# 1988 - 1989 Corvette: Recall: Evaporative Emission Hoses

**Subject:** CAMPAIGN: EVAPORATIVE EMISSION HOSES

**Model and Year:** 1988-89 CHEVROLET CORVETTE

**Bulletin Number:** 89C25 - (08/23/1993)

FIGURE 1

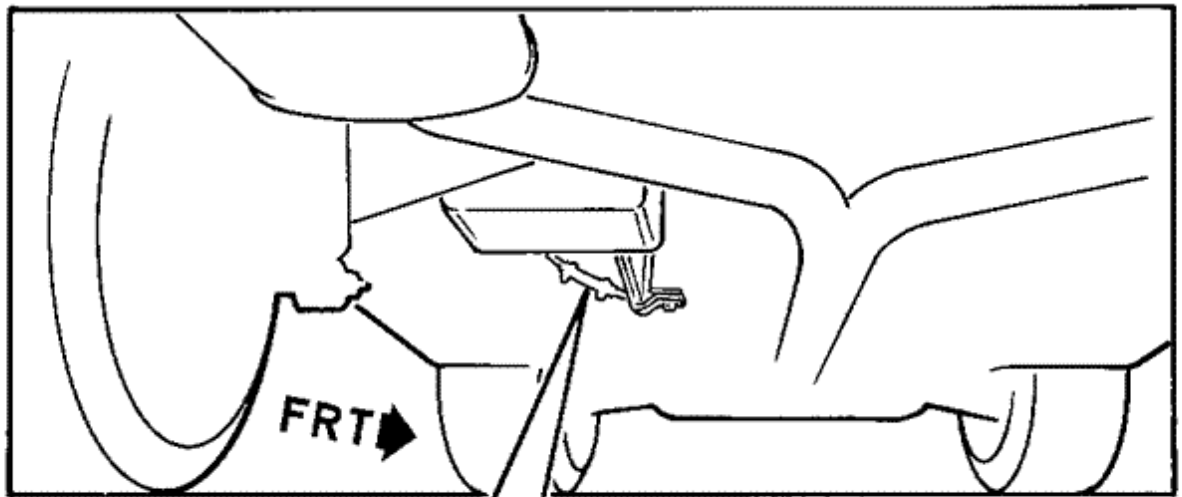
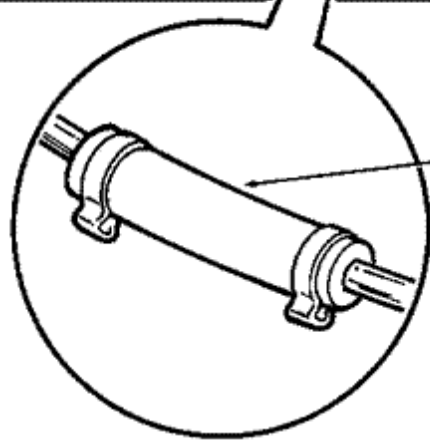
General Motors has determined that certain 1988-89 Chevrolet Corvette model vehicles may experience a condition in which two (2) suspect evaporative emission hoses may deteriorate, crack and leak.

1. Raise vehicle.
2. Referring to Figure 1, locate rubber hose (approximately 2-9/16" long - 65mm) connecting fuel tank evaporative emission pipe to chassis fore-aft evaporative emission pipe.

3. Remove both hose clamps and hose. Hose clamps and hose will not be reused.
4. Inspect pipes and bend if required to insure ends of pipes are in line with one another.

5. Install two (2) new clamps (P/N 01622744) and new hose (P/N 09442928) onto pipe ends. Insuring hose is positioned an equal distance over both ends. Position clamps onto hose and secure.

HOSE MUST BE POSITIONED  
EQUALLY OVER BOTH PIPES

FIGURE 2

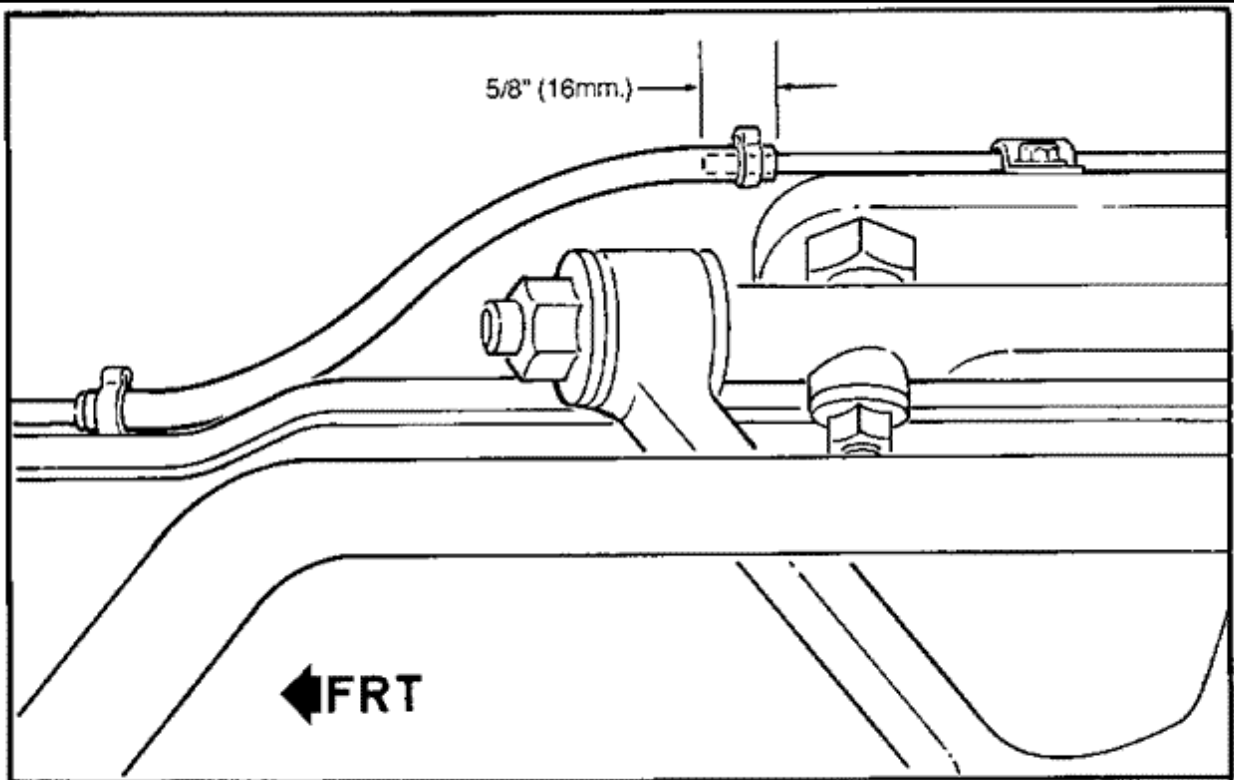
6. Lower vehicle.
7. Underhood, locate the evaporative emission hose connecting chassis fore/aft evaporative emission pipe to evaporative emission line shown in Figure 2.

8. Remove both hose clamps and hose. Hose clamps and hose will not be reused.
9. Install new large clamp (P/N 10028454) over nylon evaporative emission line, and install new small clamp (P/N 01622744) over chassis pipe.

10. Install larger end of new hose (P/N 10248651) over nylon evaporative emission line and install the opposite end approximately 1/2" over the fore/aft chassis pipe as illustrated in Figure 2.

**Notice: If hose appears taut when assembled as indicated above, repositioning of chassis fore/aft pipe may be required to alleviate condition.**
